AREA TOPOGRAPHICAL SURVEY		
PROPOSED CONVOCATION CENTER ARKANSAS STATE UNIVERSITY ONESBORO, ARK.		
PREPARED BY: HAYWOOD KENWARD & ASSOCIATES, INC. CIVIL Engineering & Surveying Jonesboro, Ark.	DATE: 10-83	SCALE: 1"=100'
DRAWN BY: J.K.		1:1

A.S.U. CONVOCATION CENTER

SITE PLAN

7/25/84

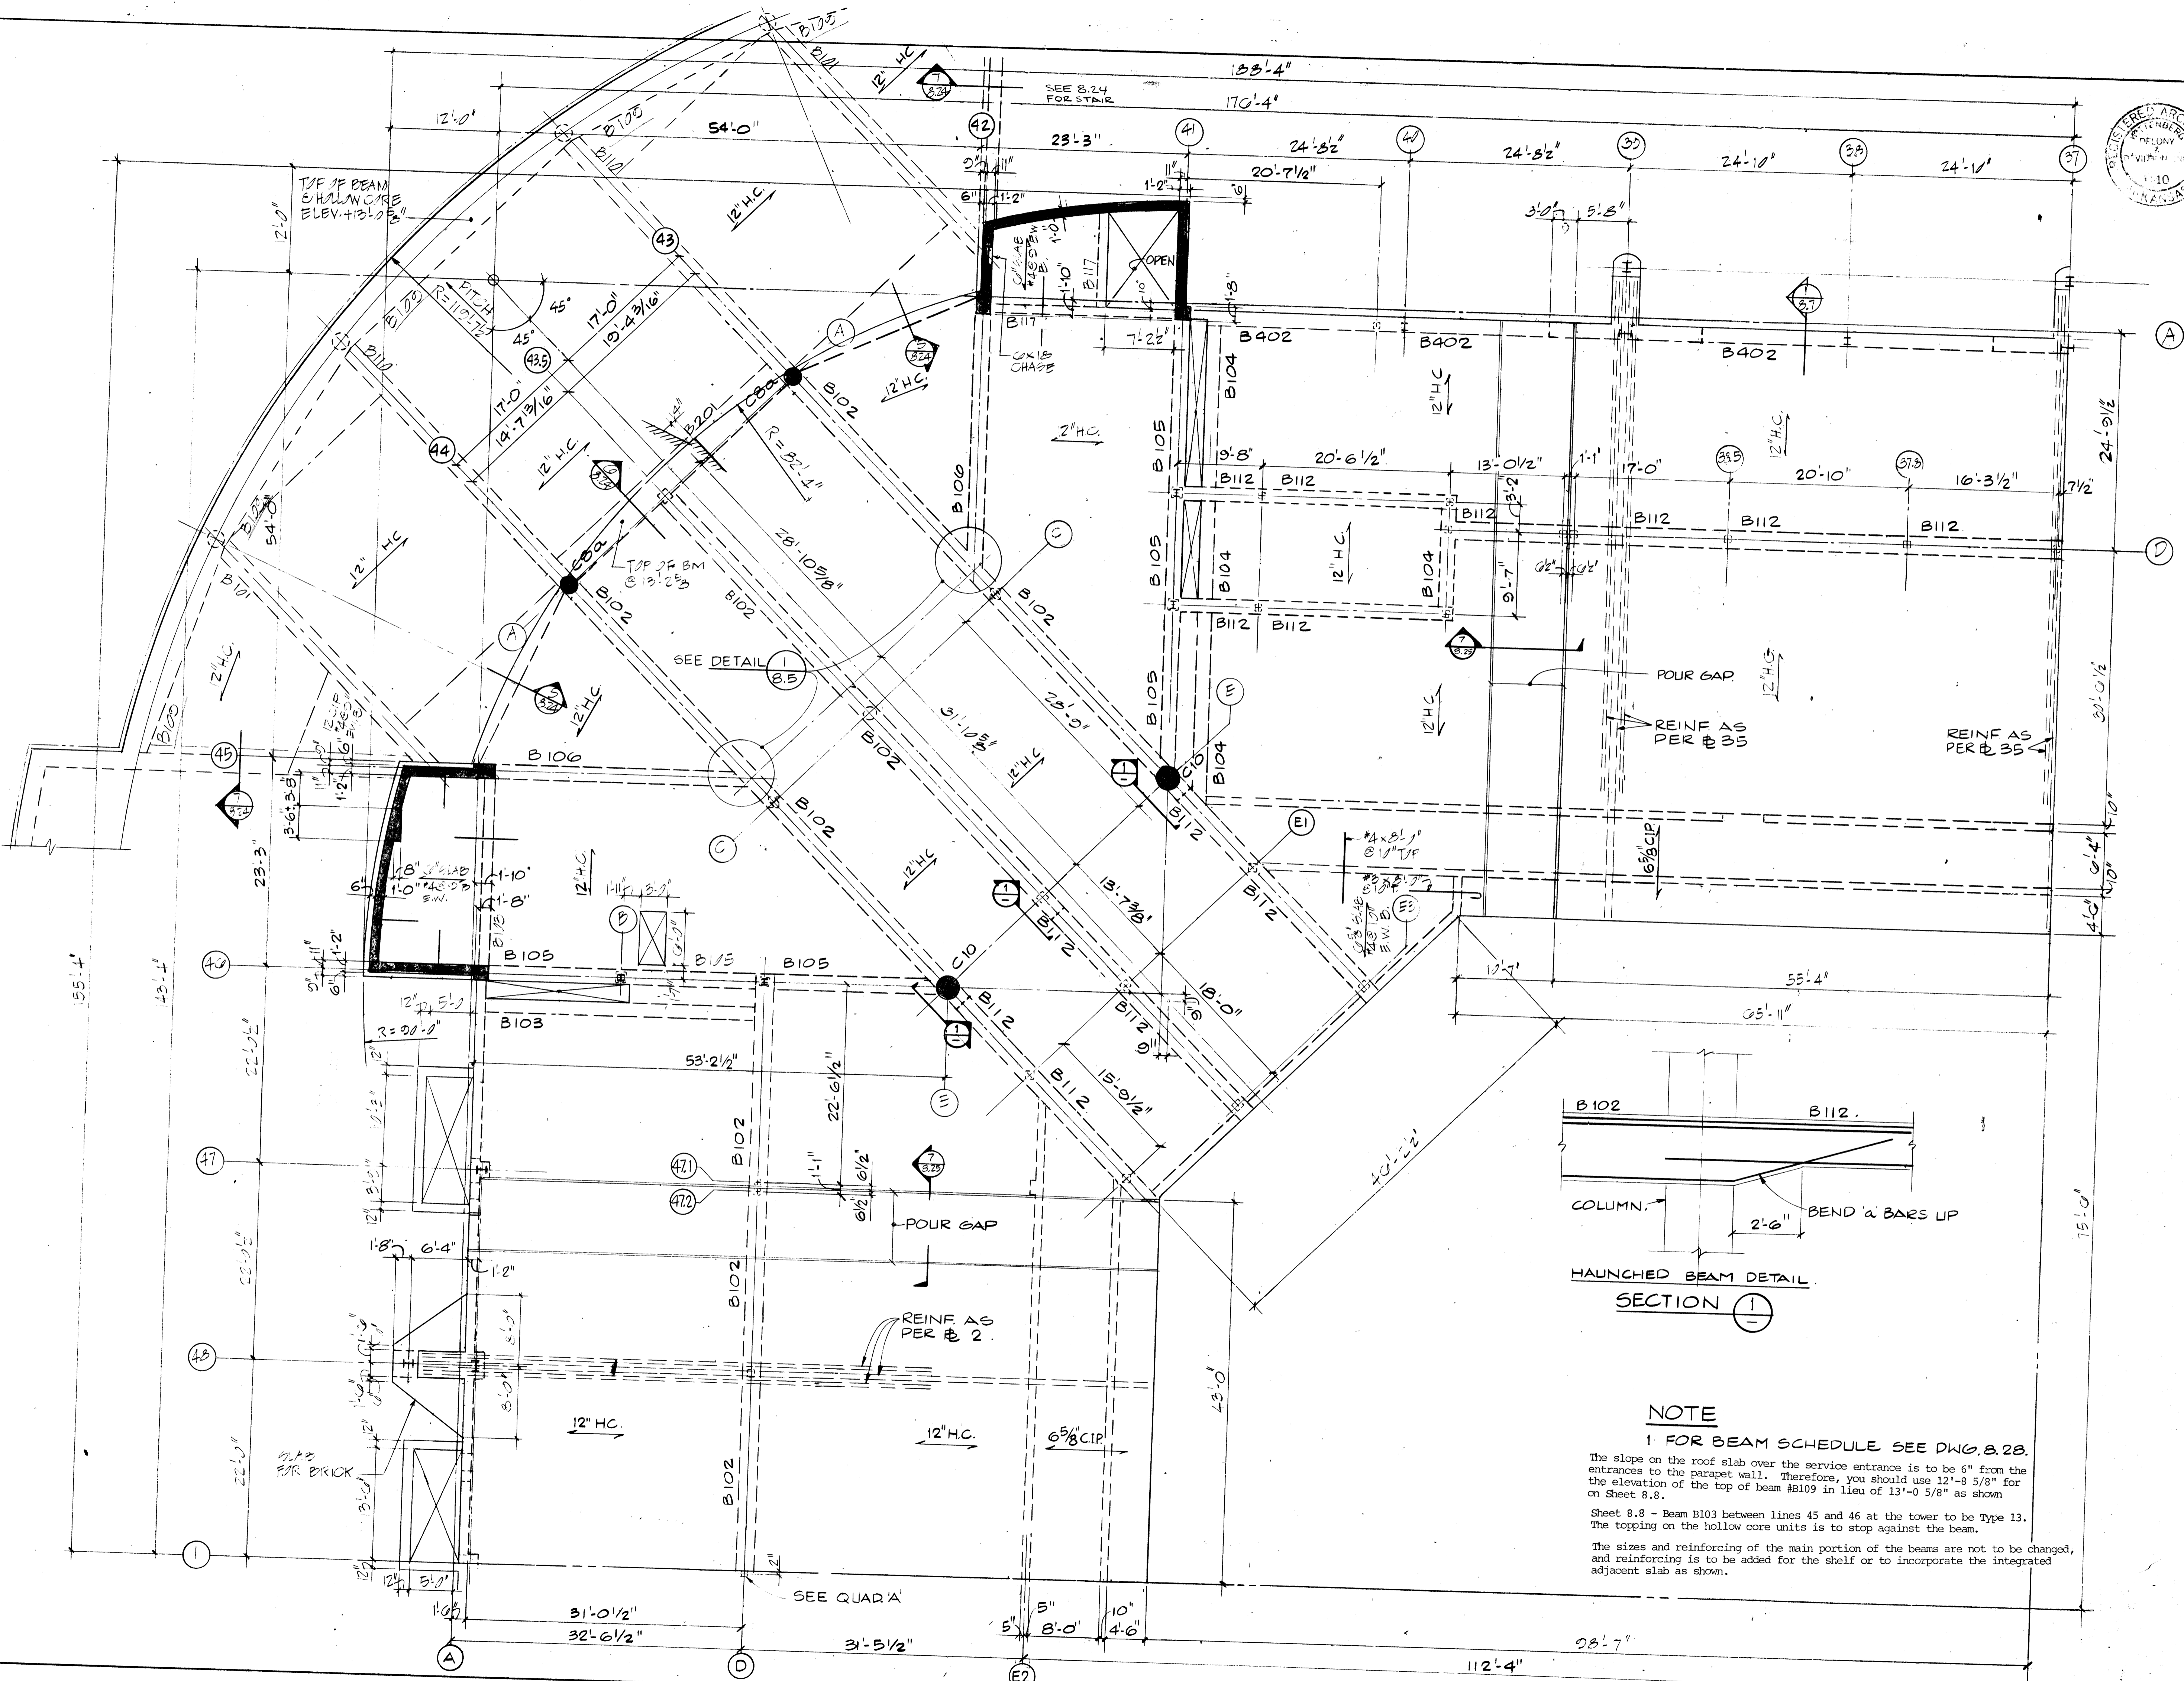
The slope on the roof slab over the service entrance is to be 6" from the entrance to the parapet wall. Therefore, you should use 12'-8 5/8" for the elevation of the top of beam #B109 in lieu of 13'-0 5/8" as shown on Sheet 8.8.

Sheet 8.8 - Beam B103 between lines 45 and 46 at the tower to be Type 13. The topping on the hollow core units is to stop against the beam.

The sizes and reinforcing of the main portion of the beams are not to be changed, and reinforcing is to be added for the shelf or to incorporate the integrated adjacent slab as shown.

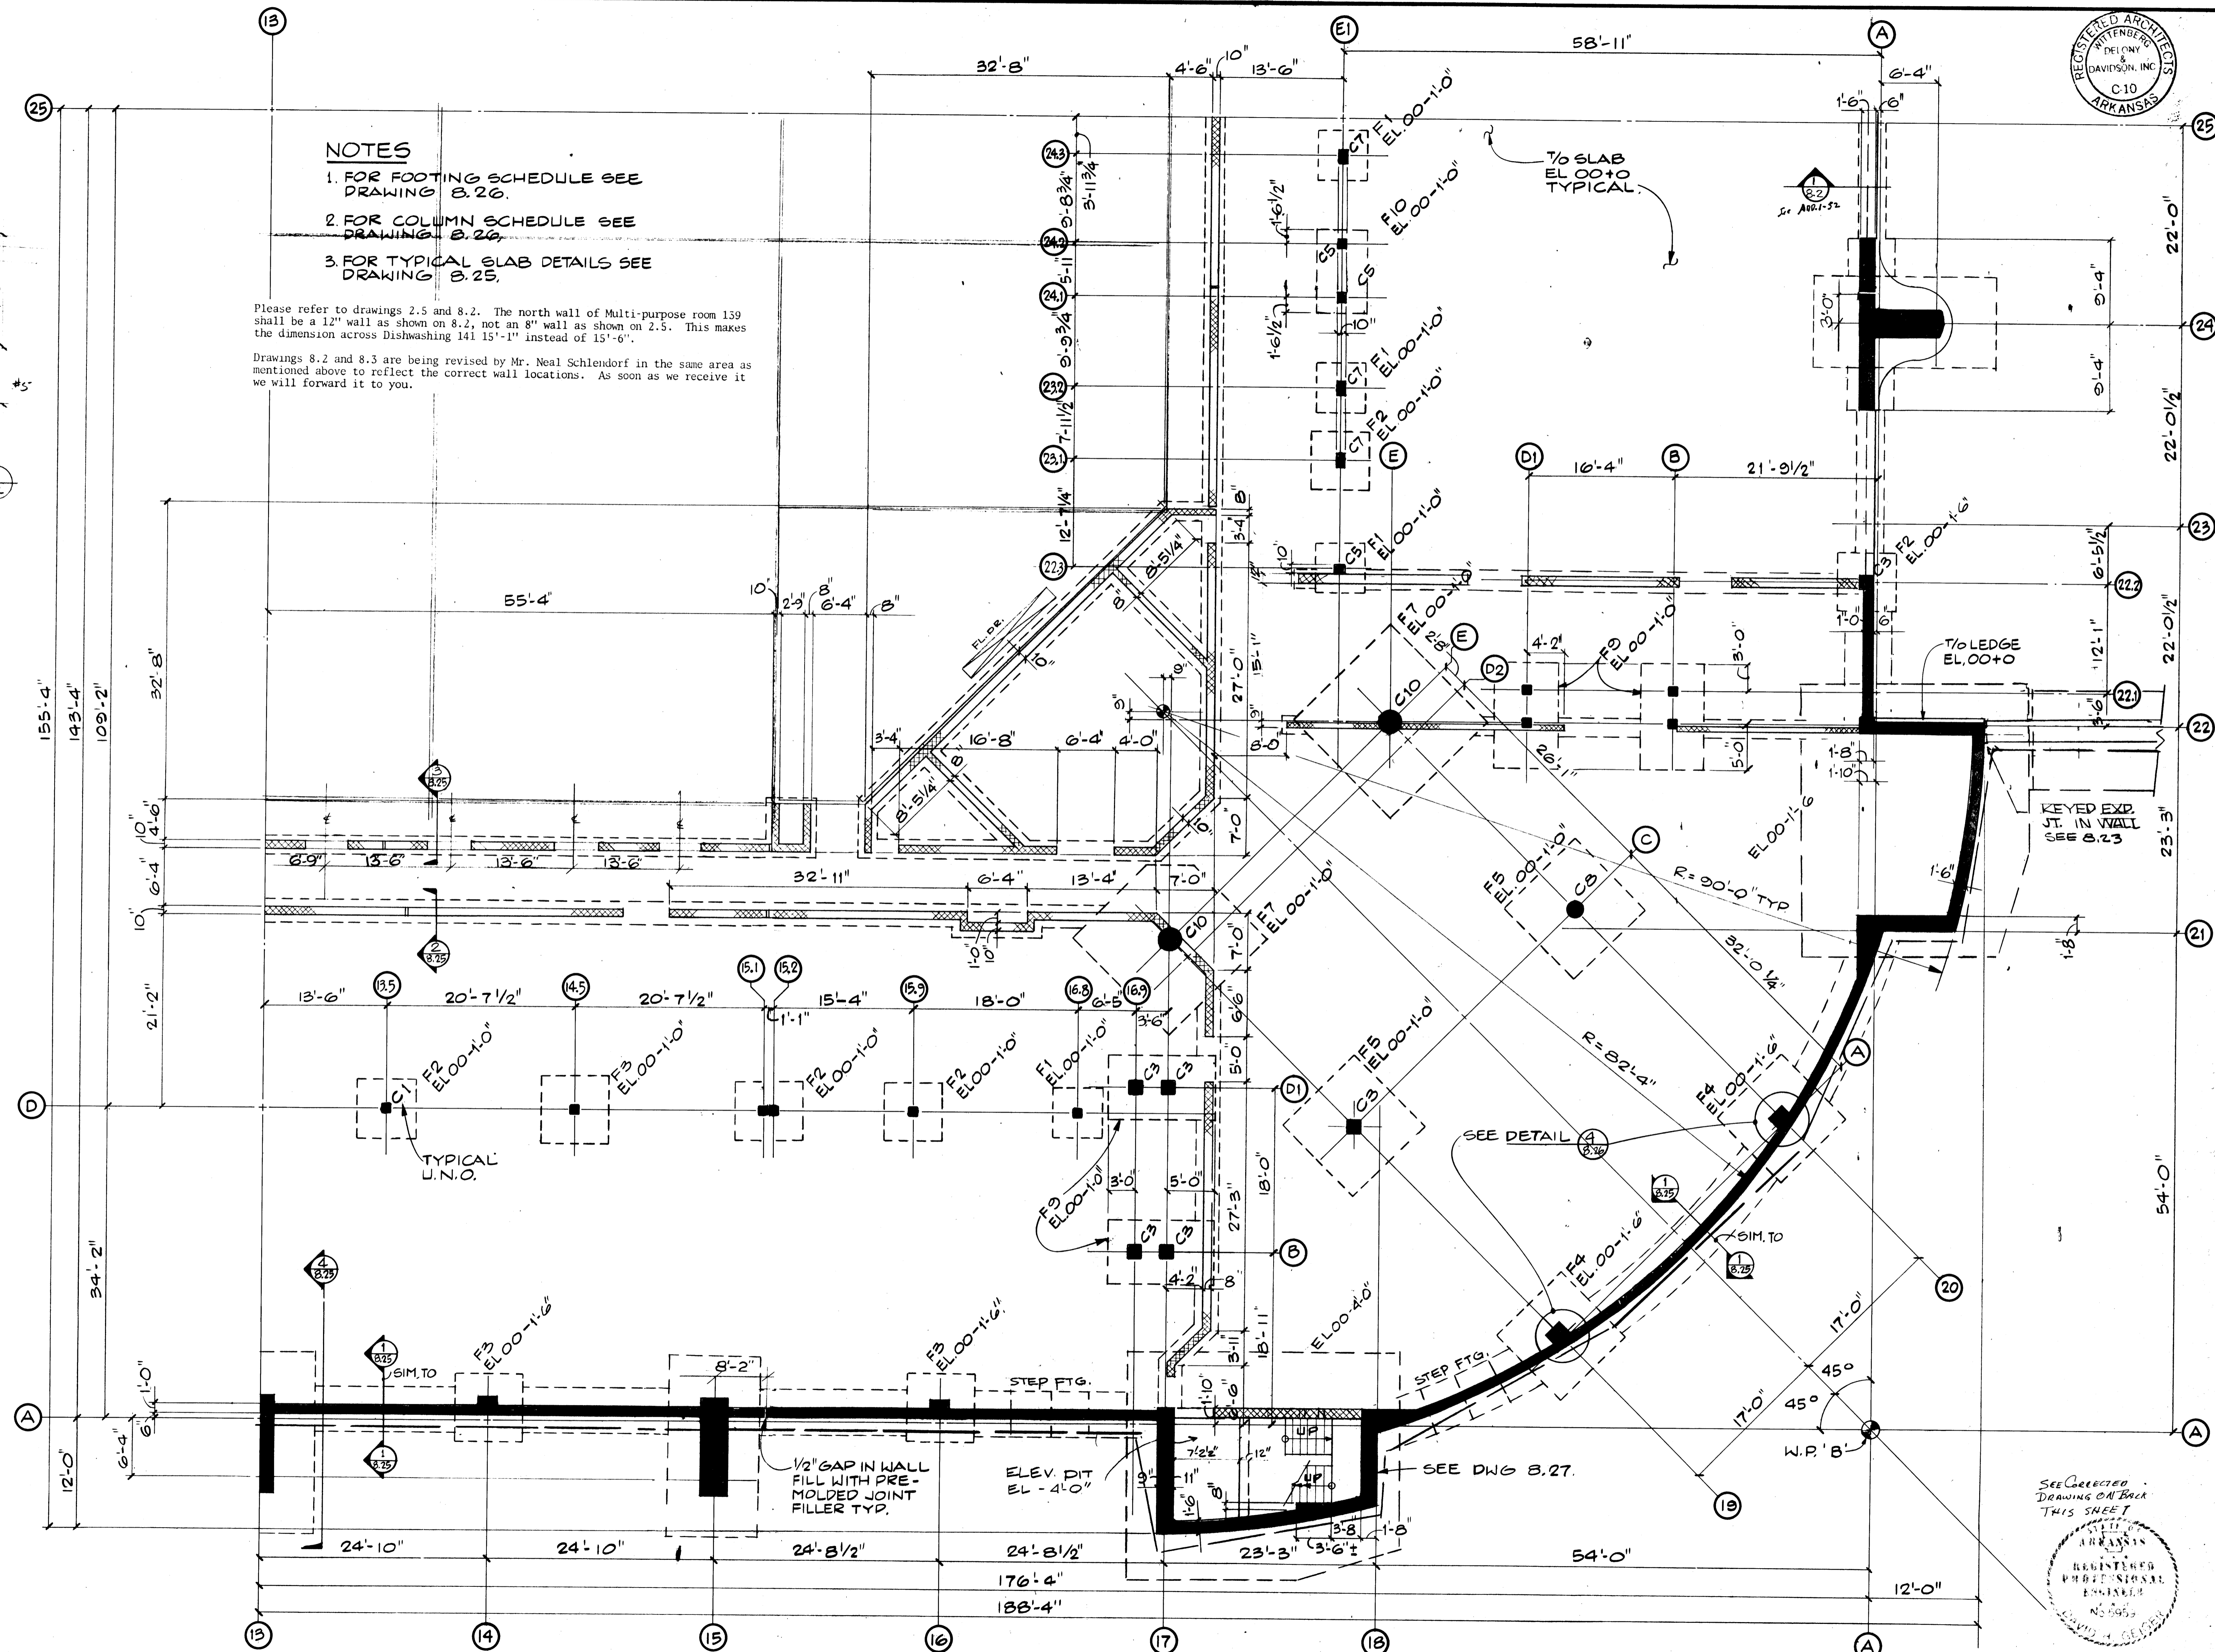
Please refer to drawings 2.5 and 8.2. The north wall of Multi-purpose room 139 shall be a 12" wall as shown on 8.2, not an 8" wall as shown on 2.5. This makes the dimension across Dishwashing 141 15'-1" instead of 15'-6".

Drawings 8.2 and 8.3 are being revised by Mr. Neal Schlendorf in the same area as mentioned above to reflect the correct wall locations. As soon as we receive it we will forward it to you.
